July 28, 1983  
Fort St. Vrain  
Unit No. 1  
P-83261

SUBJECT: Fort St. Vrain Unit No. 1  
Control Room HVAC Failure Criteria

REFERENCE: NRC Letter Dated June 27, 1983  
Madsen to Lee

# CONTROL ROOM HVAC SYSTEM - MODIFIED DESIGN FIGURE 2

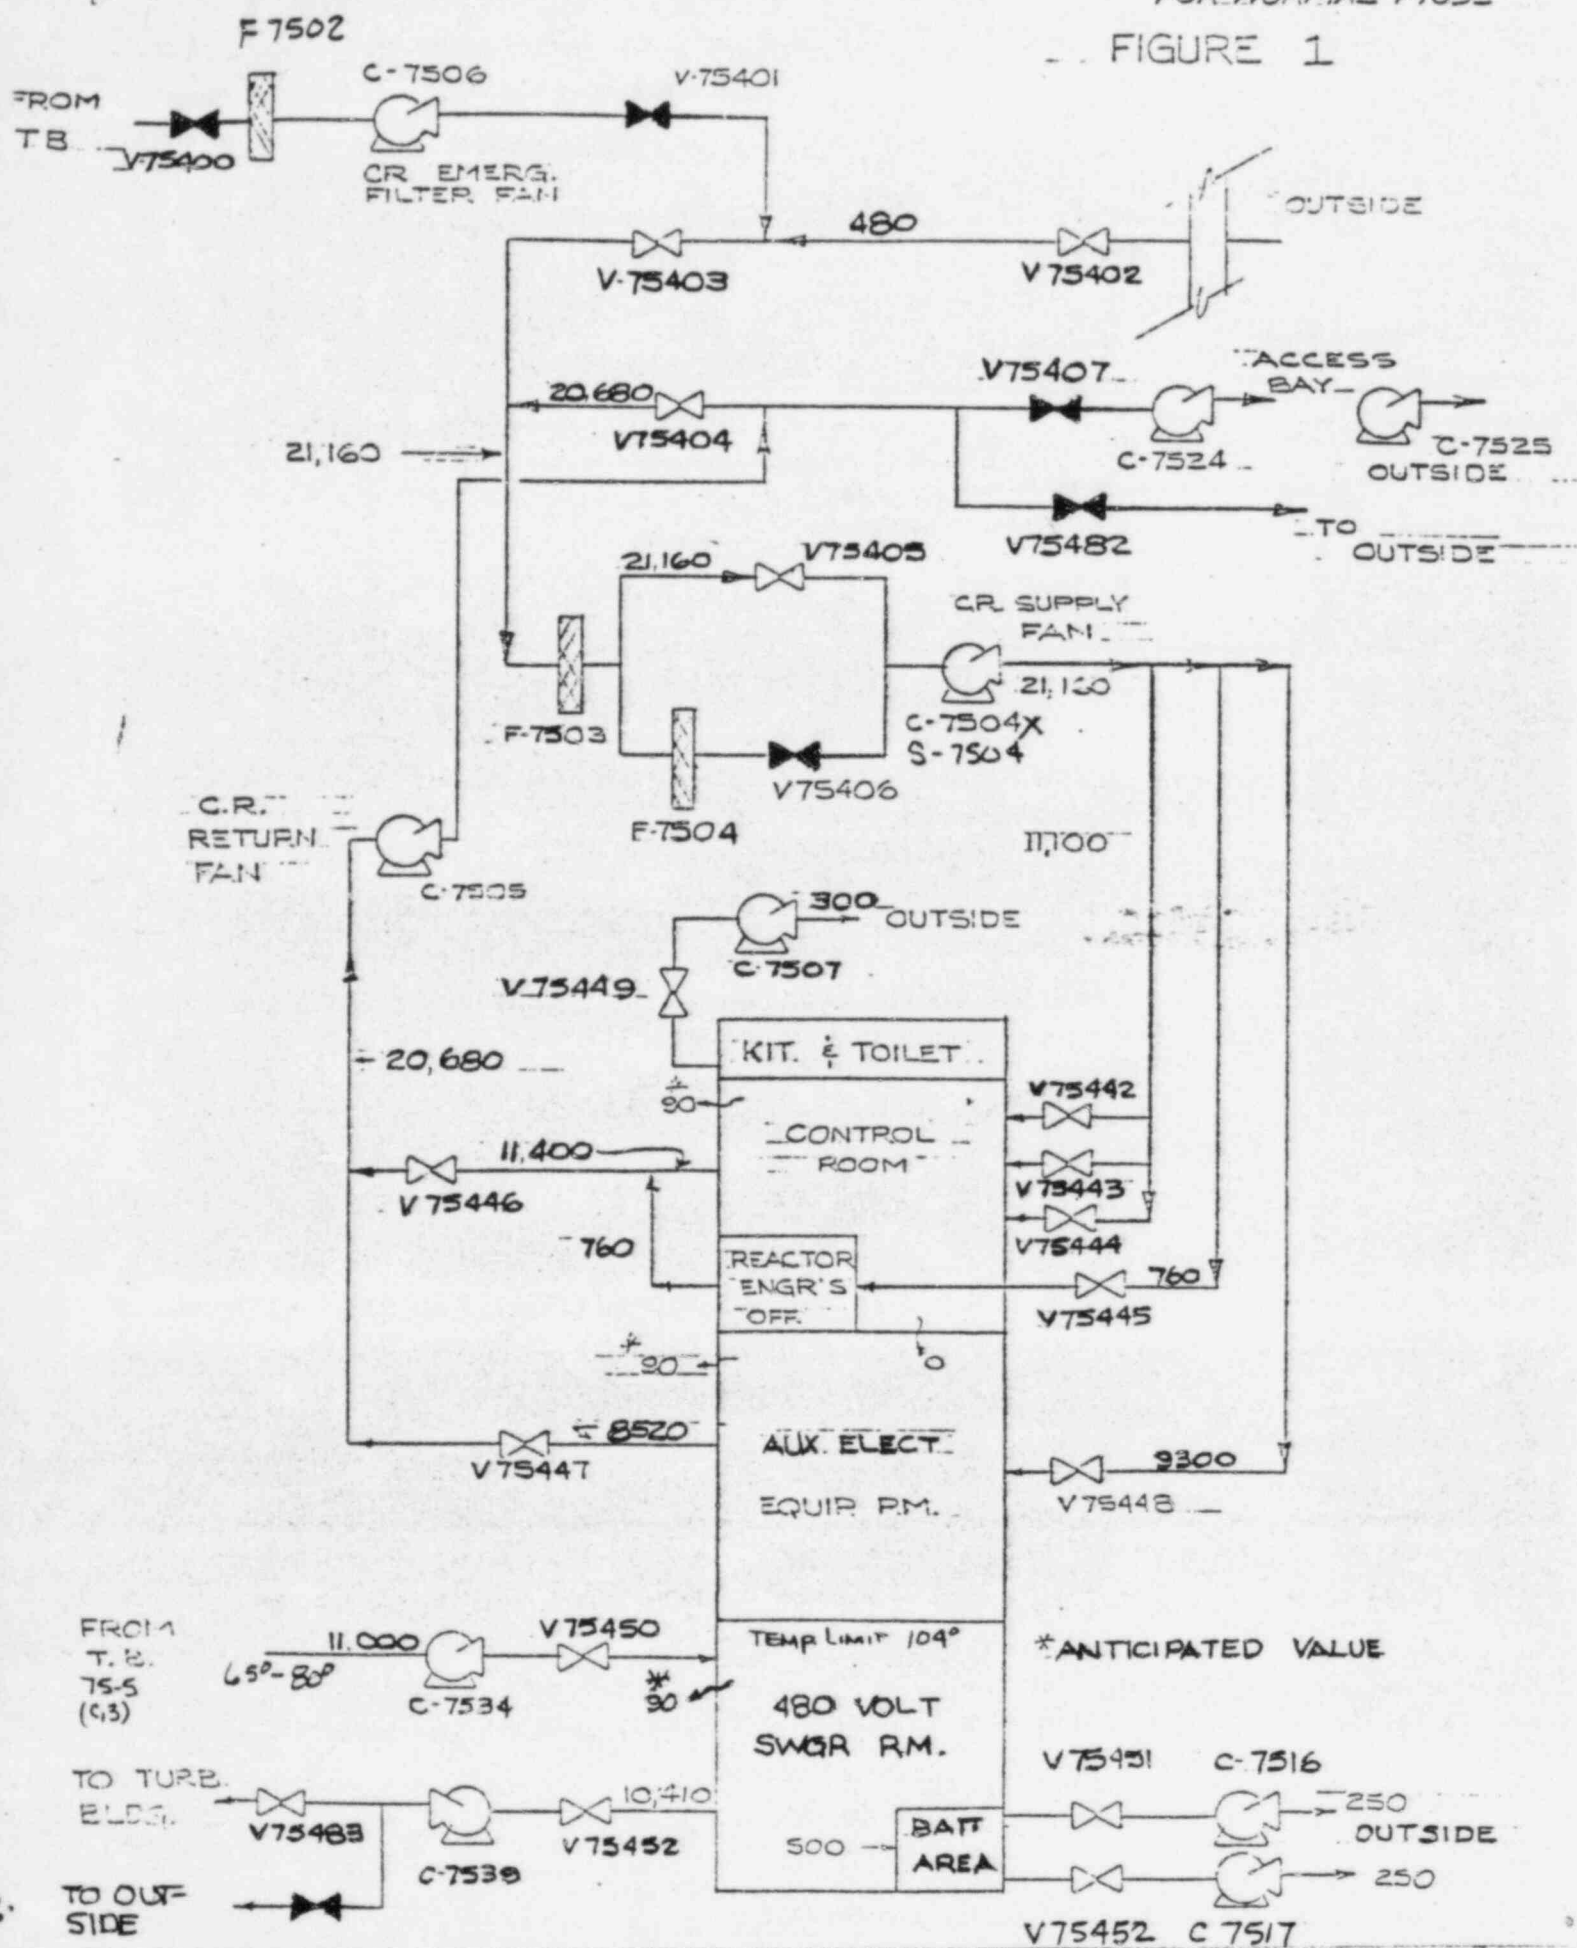
It should be noted that a modification has been implemented to identify the "V" dampers with a more conventional "DV" damper valve nomenclature. This new identification has been included for your use and information. (Figure 2)

V75482 is now identified as DV75363 and is closed during normal operation.

V75404 now identified as DV75300 is a modulating damper and is not normally closed during operation.

V75402 now DV75298  
V75405 now DV75301  
V75407 now DV75303  
V75482 now DV75363  
V75449 now DV75330  
V75400 now DV75296  
V75401 now DV75297  
V75406 now DV75302

The valve "line-up" detailed in this comment will put the Control Room and Auxiliary Electric Room in a recirculation mode with "make-up" air coming from the Turbine Building. Since the Control Room supply fan (C-7504X) is of a higher capacity than the Control Room return fan (C-7505), it is not evident that the Control Room will be subatmospheric. Low pressure in the Control Room can be detected by a pressure differential indicator (PDI-7556), and low flow at the discharge of C-7506 will alarm XA-7501-1. Corrective action might include modulation of damper DV-75327 (formerly V-75446) or shutting down of return fan C-7505.
